FINAL MITIGATION PLAN

BANNER FARM MITIGATION SITE

Henderson County, NC
NCDEQ Contract No. 7530
DMS ID No. 100062

Re: NCIRT Review and USACE Approval of the NCDMS Banner Farm Mitigation Site /
Henderson Co./ SAW-2018-01153/ NCDMS Project # 100062

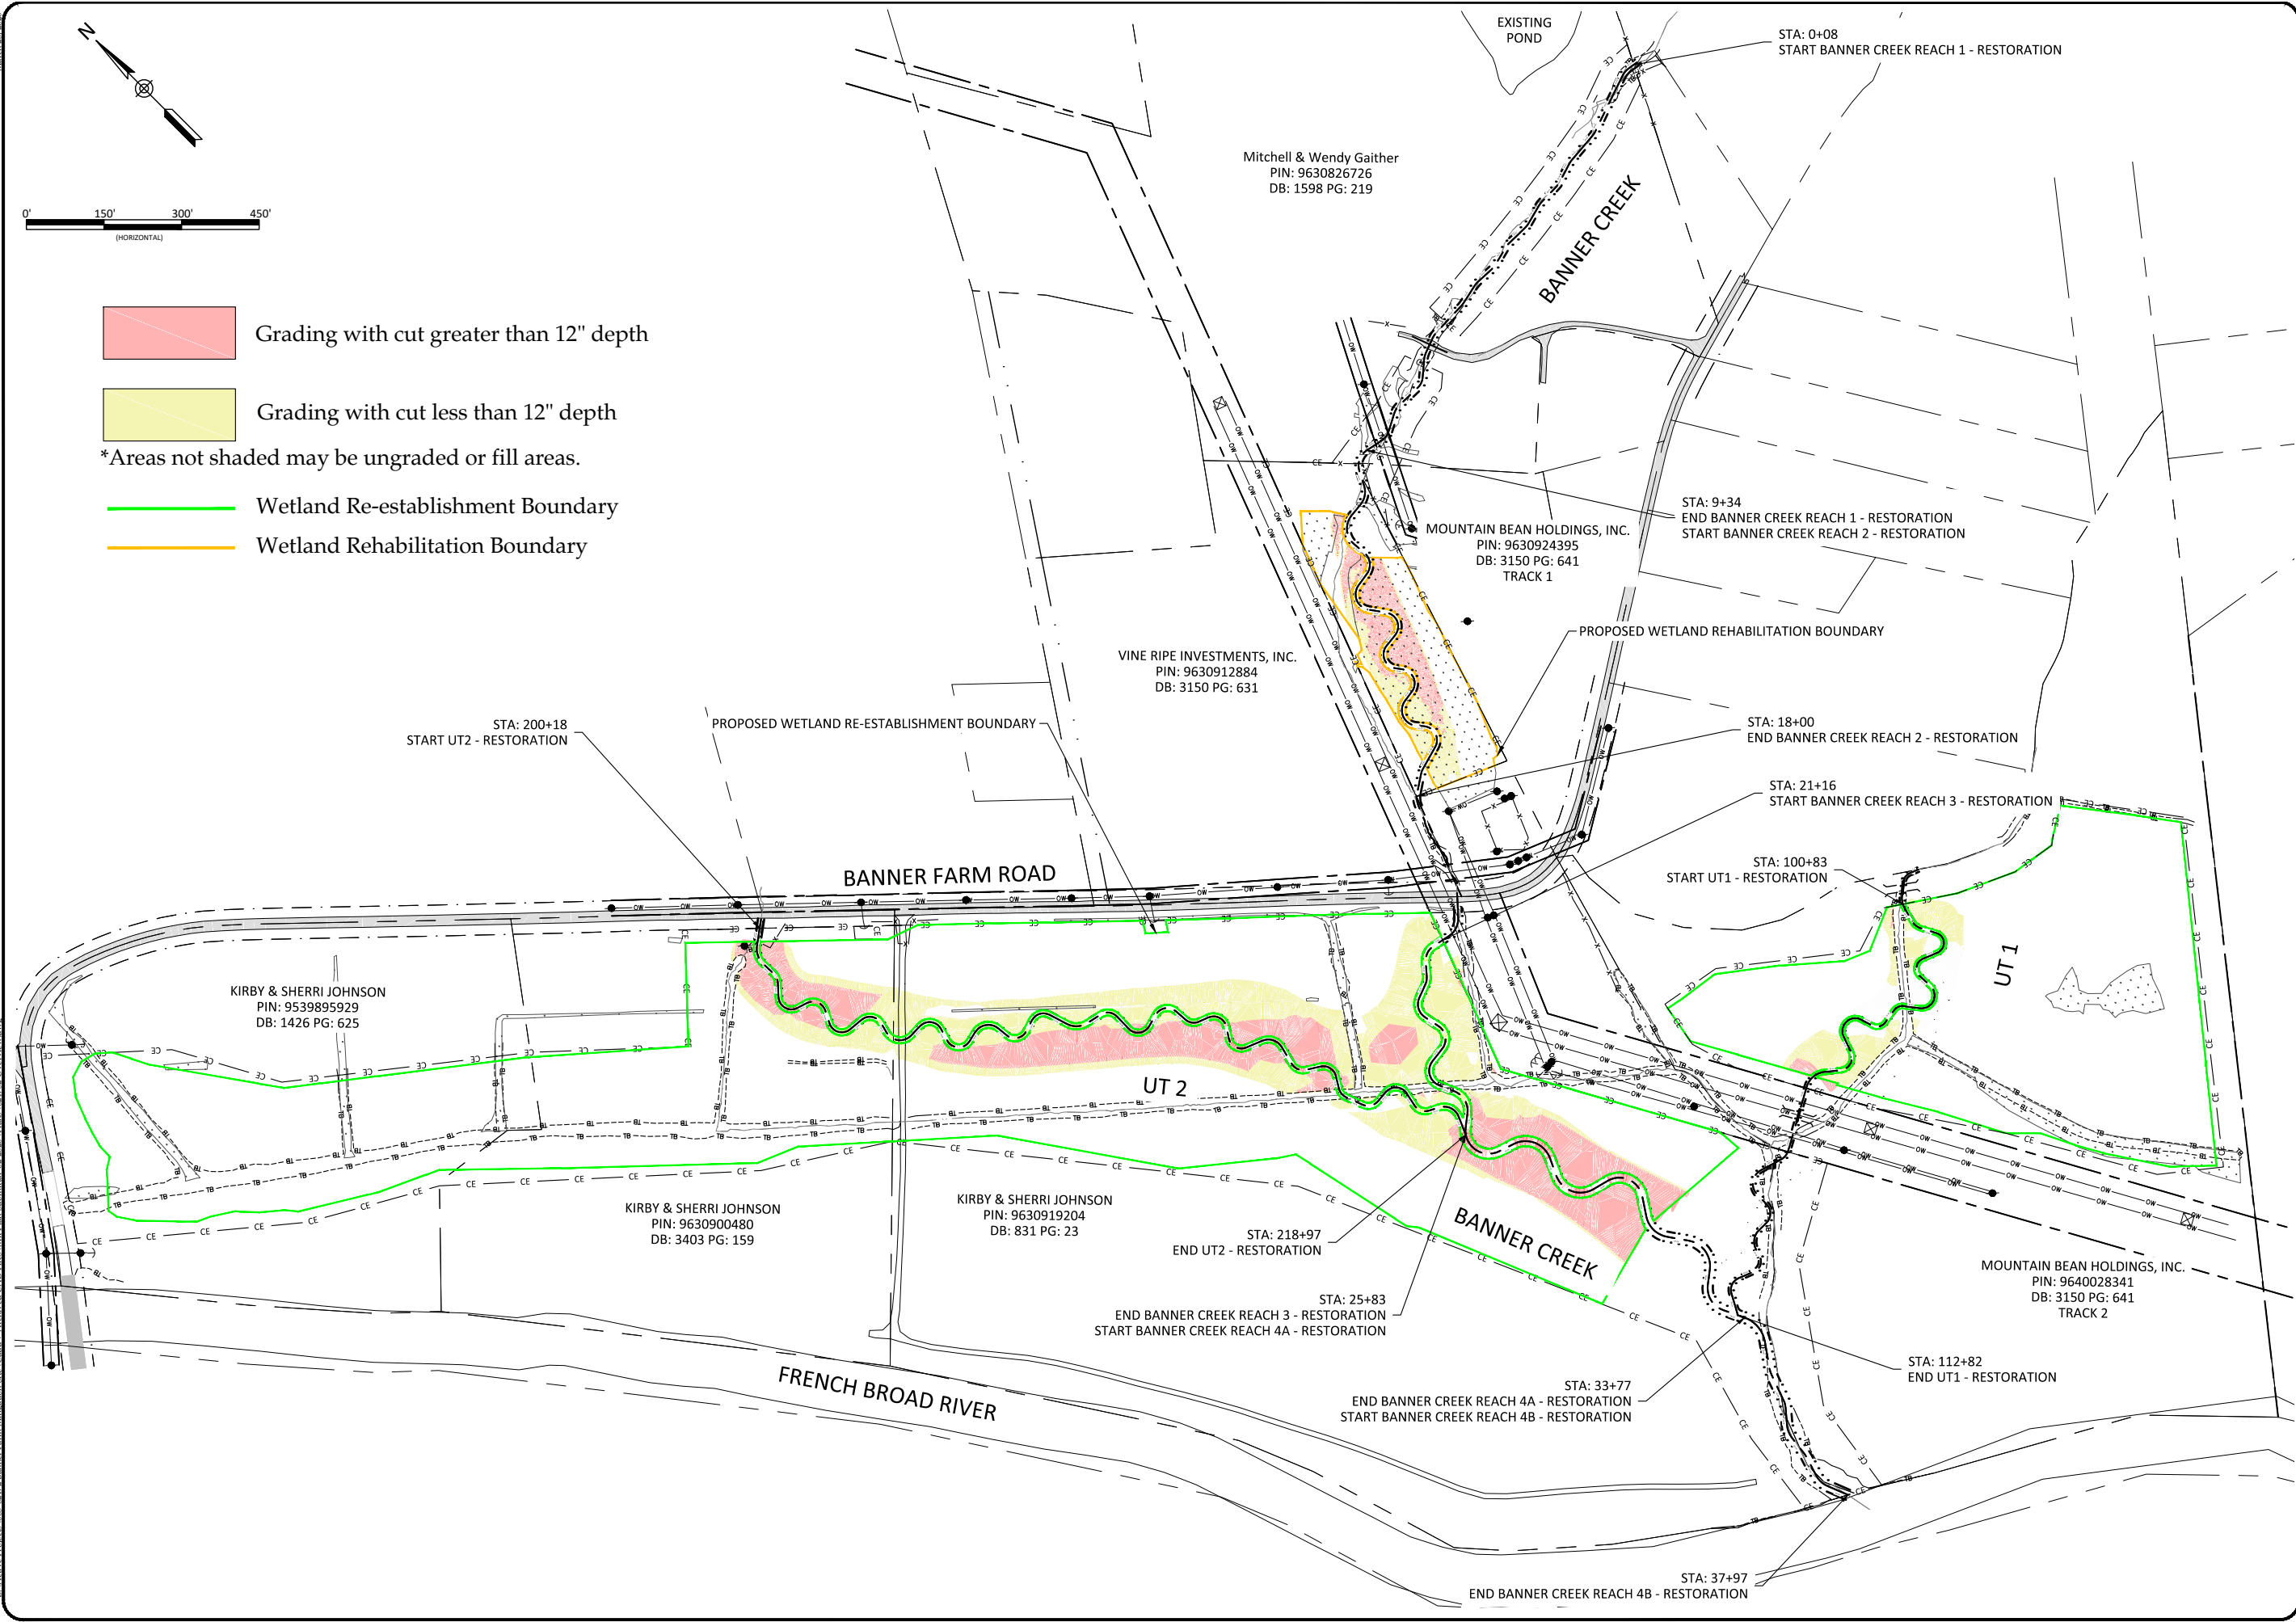
21. Appendix 8 –
 - a. Sheet 0.3 – For clarity, can you please reference the “CR, JR, CH, RR” used within the proposed bankfull icon on the plan views.
 - b. Sheet 0.3 – It would help our review to see the existing channel areas proposed to be filled as a shaded feature on the plan view sheets.

b. Sheet 0.3 – It would help our review to see the existing channel areas proposed to be filled as a shaded feature on the plan view sheets.

Sheet 0.2 Project Overview: Please include north arrow and scale.

- **Sheet 0.2 Project Overview:** *Please include north arrow and scale.*
 - North arrow and scale were added to the Overview Sheet. Other Sheets were reviewed to verify that

Area to be filled were shaded on the project overview (Sheet 0.2). Note that shaded areas indicate ditches or existing channels that will be filled to the existing top of bank for those entities. Other areas of ditches or existing channels that show proposed grading (proposed topography contours) will also likely be filled, however they may not be filled all the way to the top of bank. Areas with proposed topography contours should be interpreted independently based on the contours.

Figure 1 Vicinity Map
Banner Farm Mitigation Site
French Broad River Basin 06010105

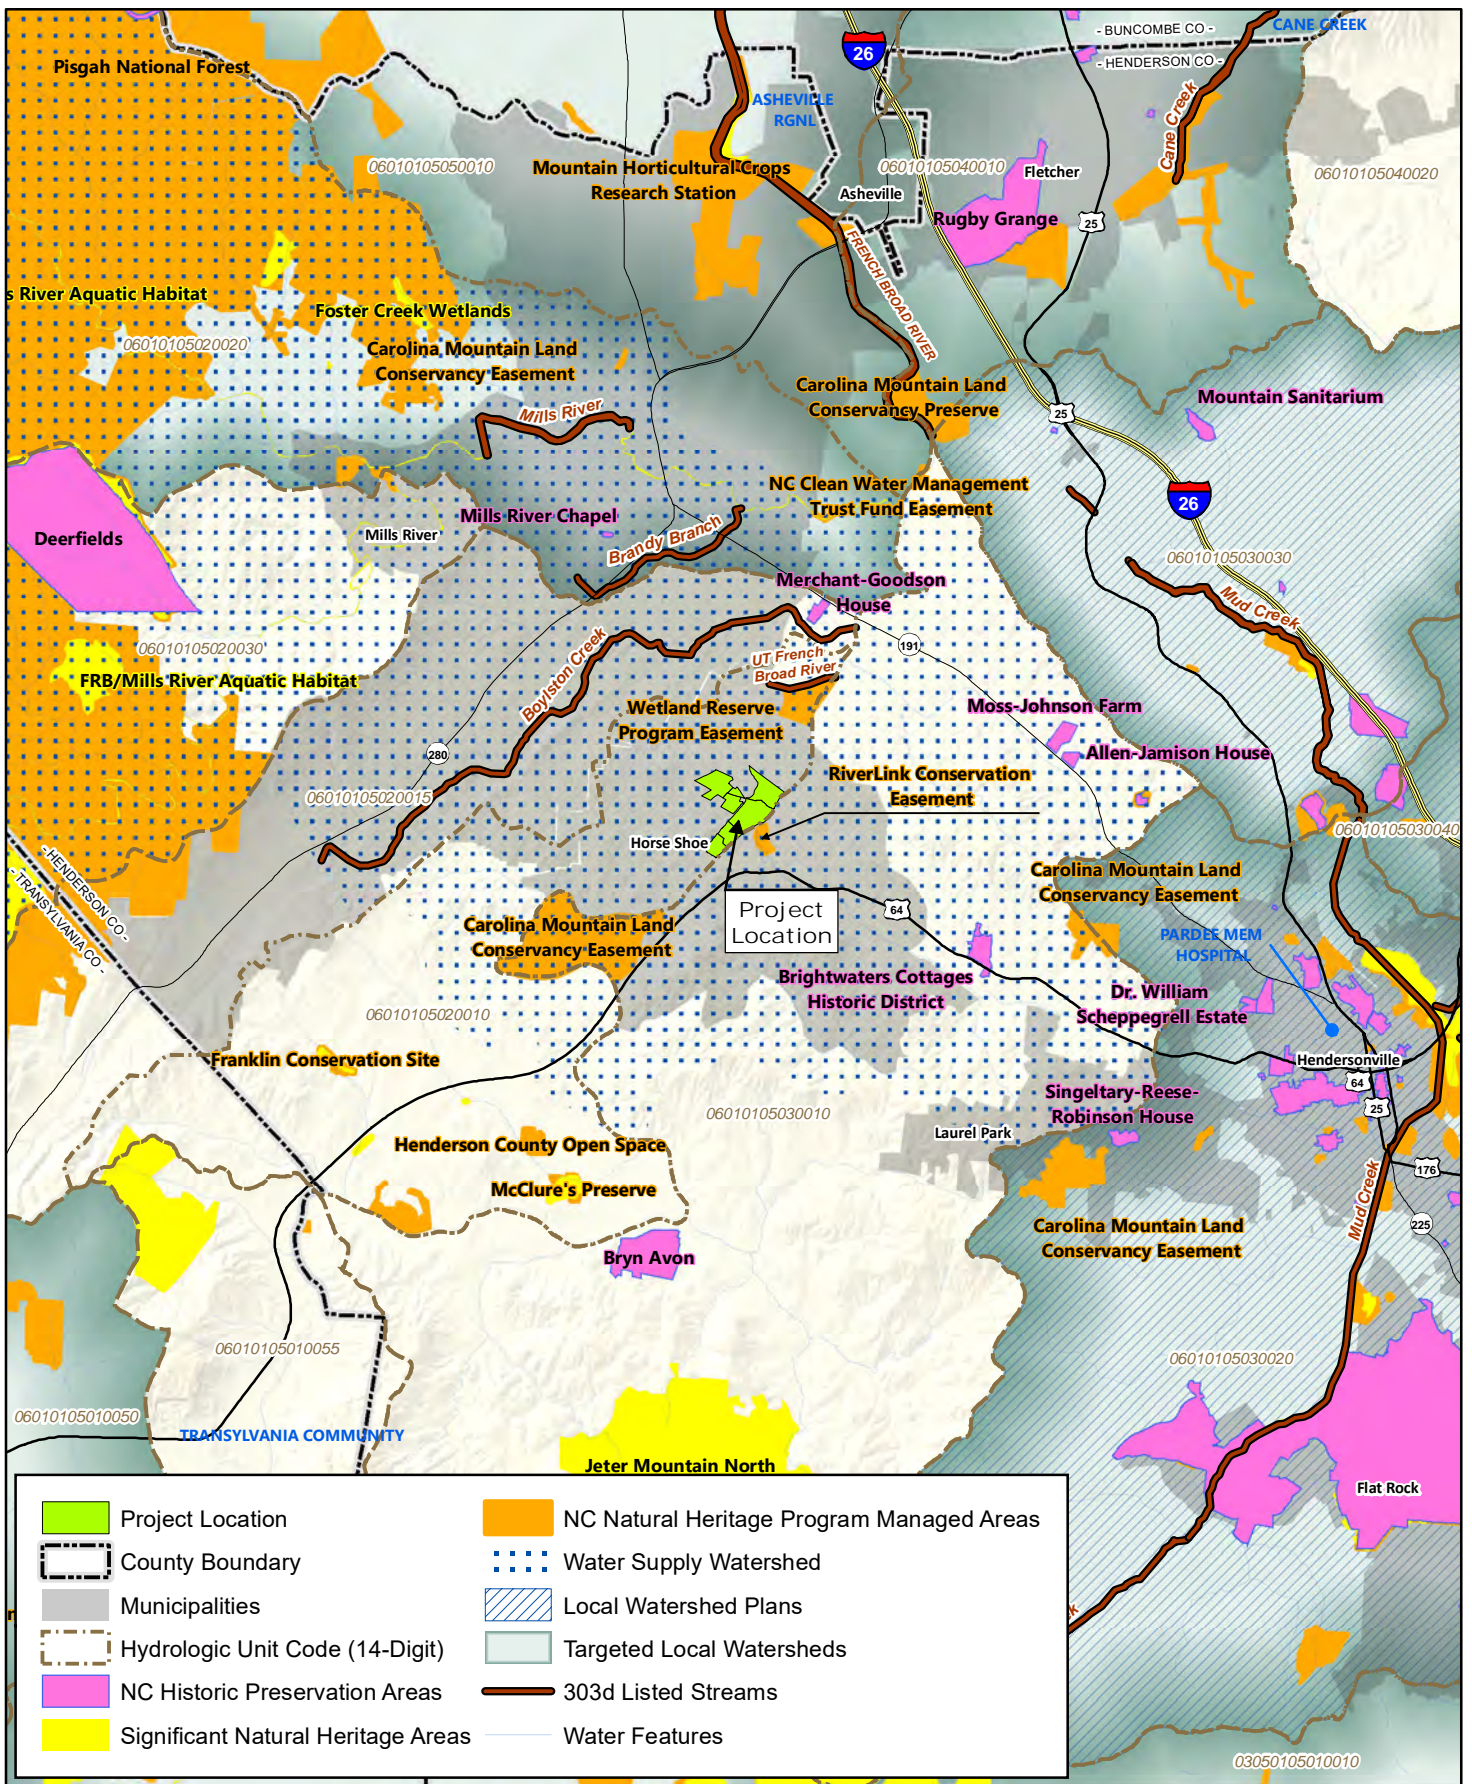
Section 1.0/Figure 1 Vicinity Map: Horse Shoe is not shown on Figure 1 as discussed in Section 1.0. Please update.

- **Section 1.0/Figure 1 Vicinity Map:** *Horse Shoe is not shown on Figure 1 as discussed in Section 1.0. Please update.*
 - Horse Shoe was added to Figure 1.

Figure 6 Existing Conditions Map
Banner Farm Mitigation Site
French Broad River Basin 06010105

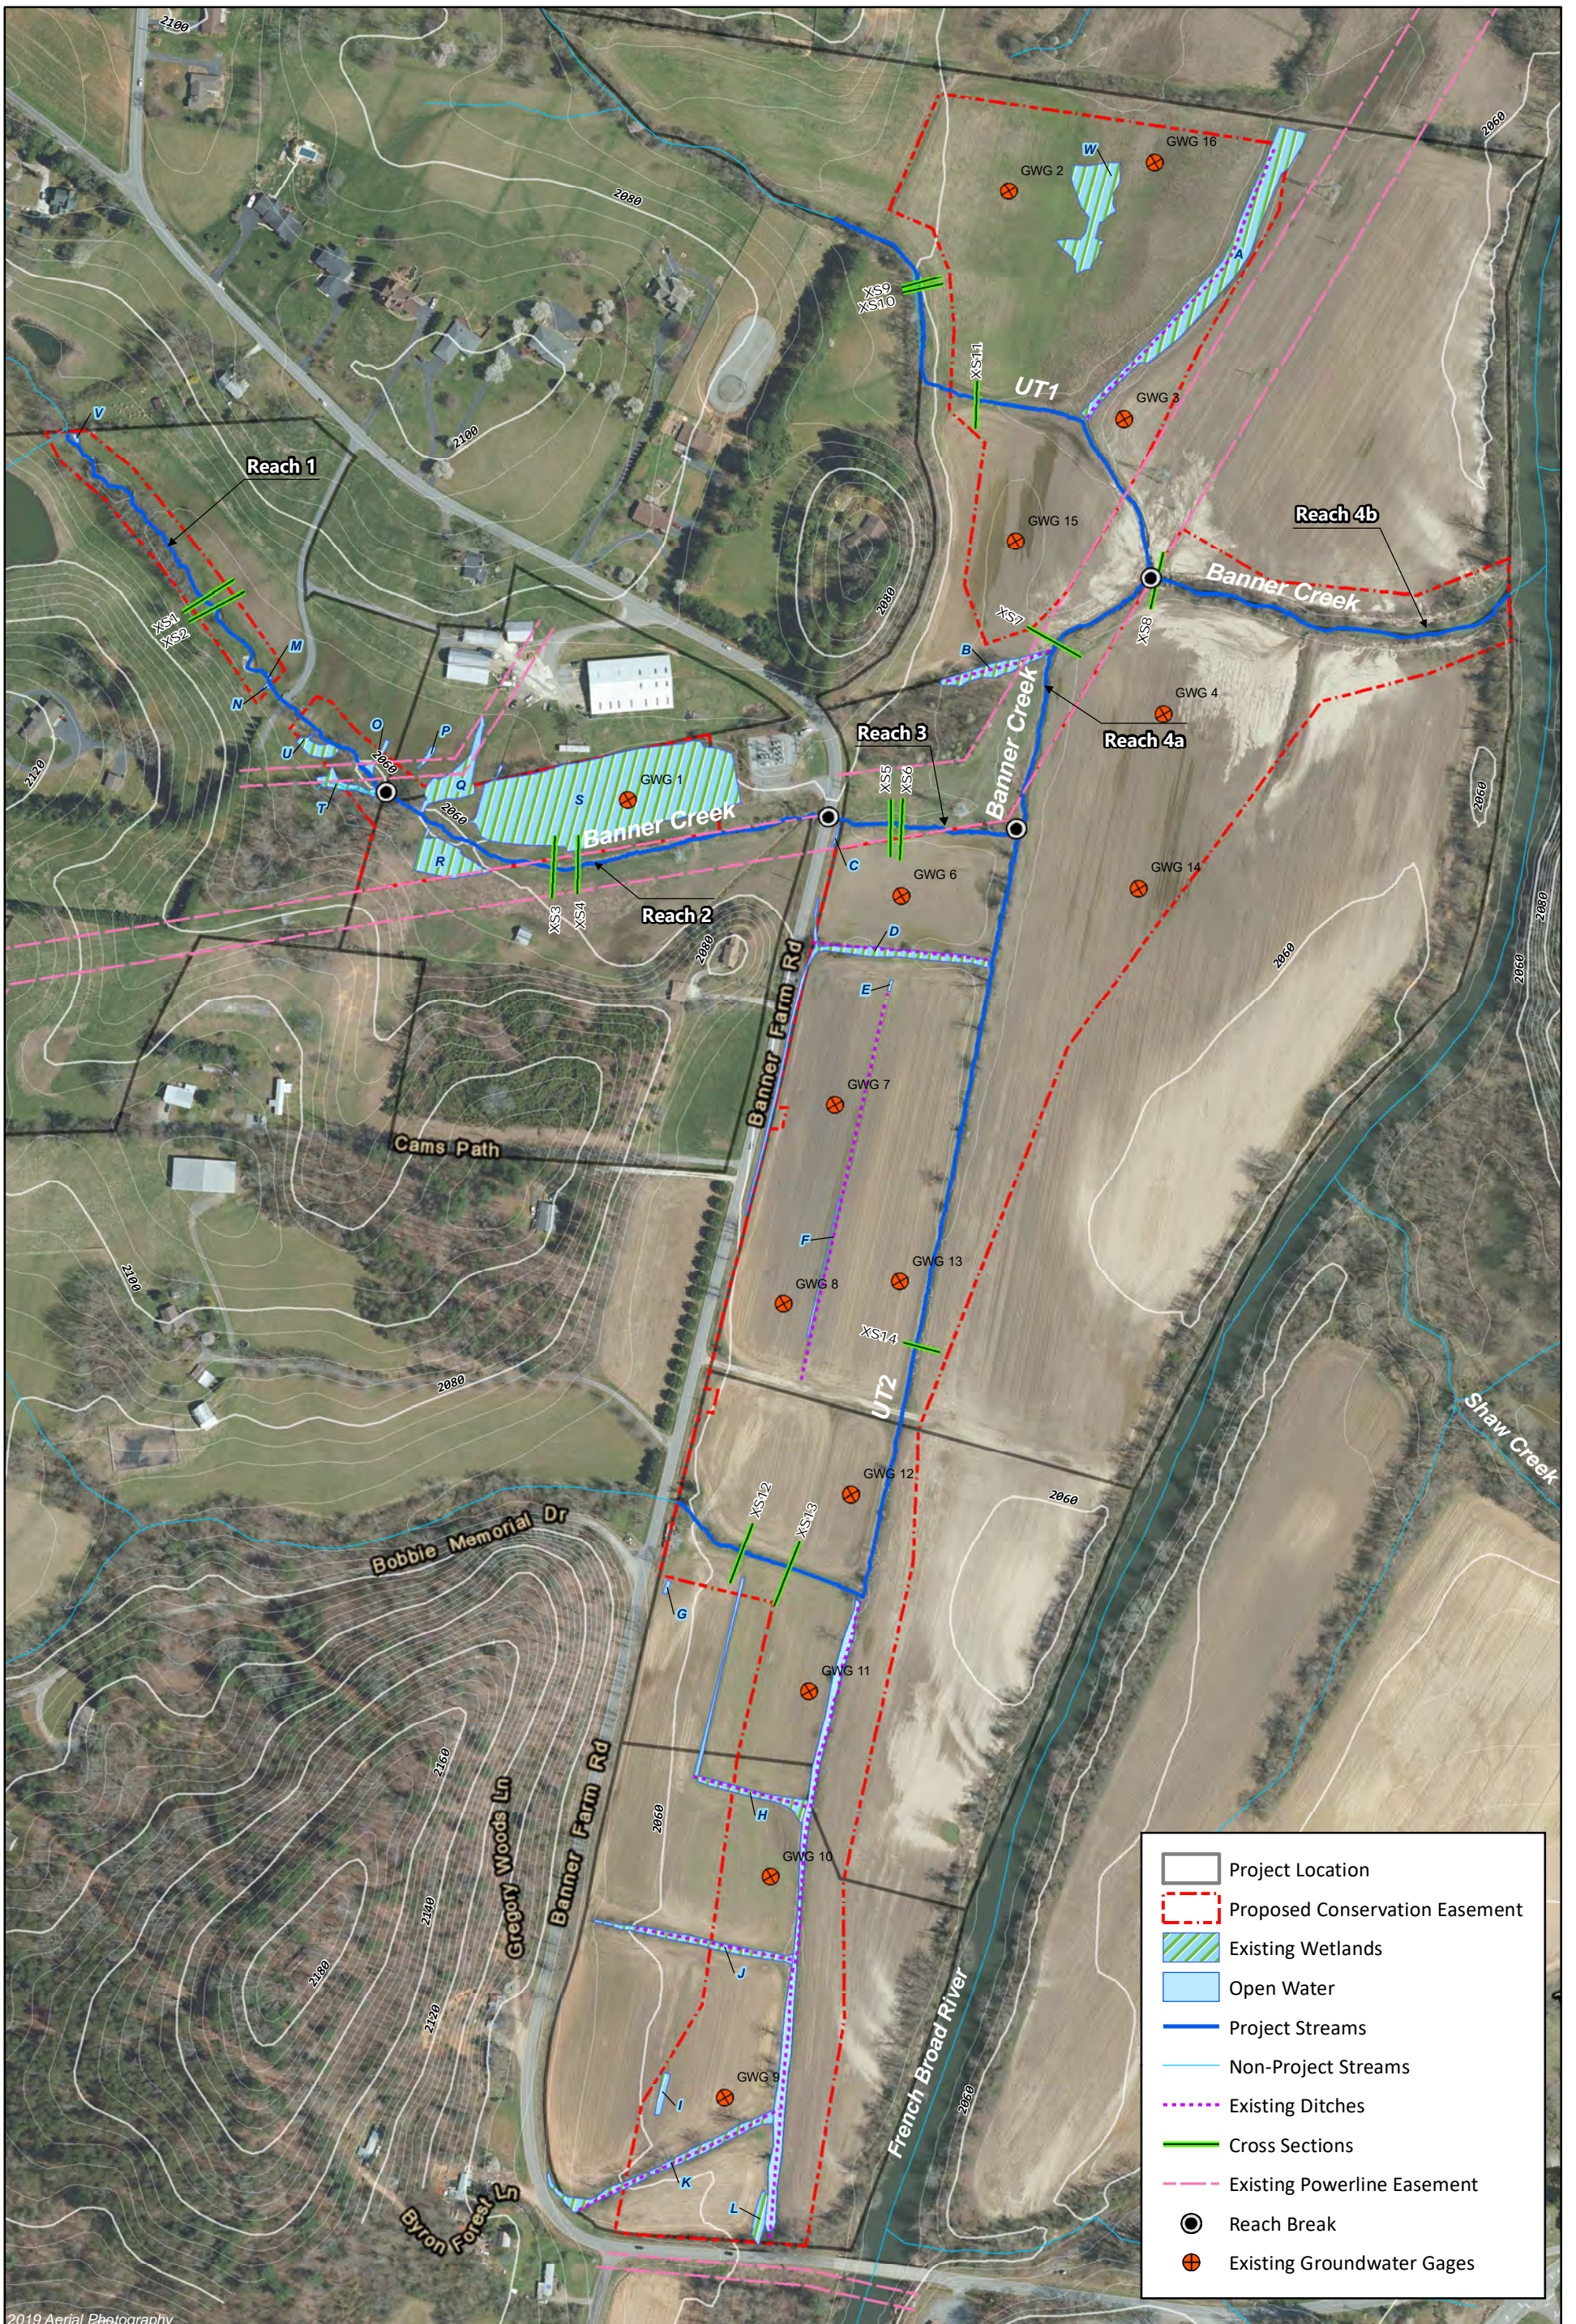
8. Figure 6 shows Wetland T, but Figure 10 shows this area as a small tributary. Table 9 indicates that this area will have a temporary impact of 0.04 ac from floodplain grading. Please clarify what is happening in this area when submitting the PCN.

8. *Figure 6 shows Wetland T, but Figure 10 shows this area as a small tributary. Table 9 indicates that this area will have a temporary impact of 0.04 ac from floodplain grading. Please clarify what is happening in this area when submitting the PCN.*
